# Access Compliance Report

## Public Rights-of-Way

### (Curb Ramps)

Intersection ID: 14846	Main Street: HENLEY_PL	Cross Street: S_KINGS_DR	Location: E
ADA ID: 18C16DB15246	Ramp Type: Perp	Initial Pass/Fail: Fail	Overall Compliance: No
Codes/Mitigation Info/Possible Solution		Field Measurements/Component Compliance	
Severity Score: 26.25

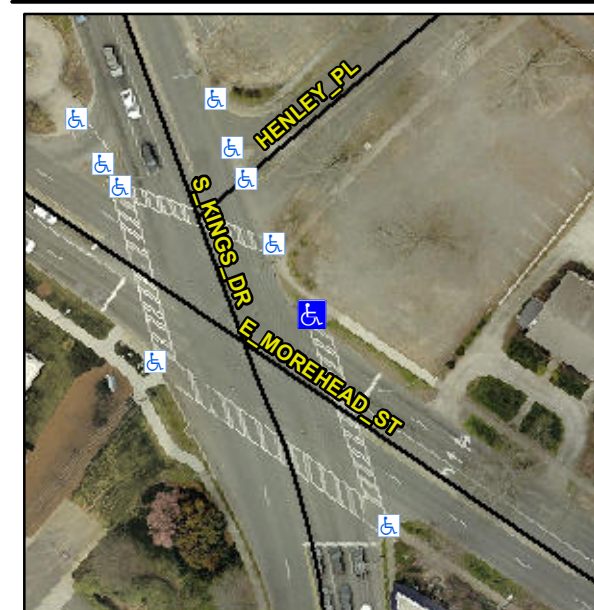
**Remove & Replace Entire Ramp.**

**Not Found, R304.2.2**

Compliance	Description	Data	Compliance	Description	Data
N/A	Ramp Length (in)	69.0	No	Ramp Slope (%)	12.8
Yes	Ramp Width (in)	48.0	Yes	Ramp XSlope (%)	2.4
N/A	Flare Type LT	N/A	N/A	Flare Type RT	N/A
N/A	Flare Slope LT (%)	N/A	N/A	Flare Slope RT (%)	N/A
N/A	Flare Traversable LT?	N/A	N/A	Flare Traversable RT?	N/A
N/A	Landing Length (in)	N/A	N/A	DWS Provided?	N/A
N/A	Landing Width (in)	N/A	N/A	DWS Contrast?	N/A
N/A	Landing Slope (%)	N/A	N/A	DWS Length (in)	N/A
N/A	Landing X Slope (%)	N/A	N/A	DWS Full Width?	N/A
N/A	Landing Curb? (Y/N)	N/A	N/A	DWS Offset (in)	N/A
N/A	Shared Landing?	N/A			
N/A	Gutter Ponding?	N/A	N/A	Gutter Slope (%)	N/A
N/A	Gutter Lip Ht (in)	N/A	N/A	Gutter X Slope (%)	N/A
N/A	Painted X Walk1?	Yes	N/A	Painted X Walk2?	N/A
	X Walk 1 Direction	To S		X Walk 2 Direction	N/A
N/A	X Walk 1 Width (in)	177.0	N/A	X Walk 2 Width (in)	N/A
	X Walk 1 Slope (%)	4.5		X Walk 2 Slope (%)	N/A
	X Walk 1 X Slope (%)	3.0		X Walk 2 X Slope (%)	N/A
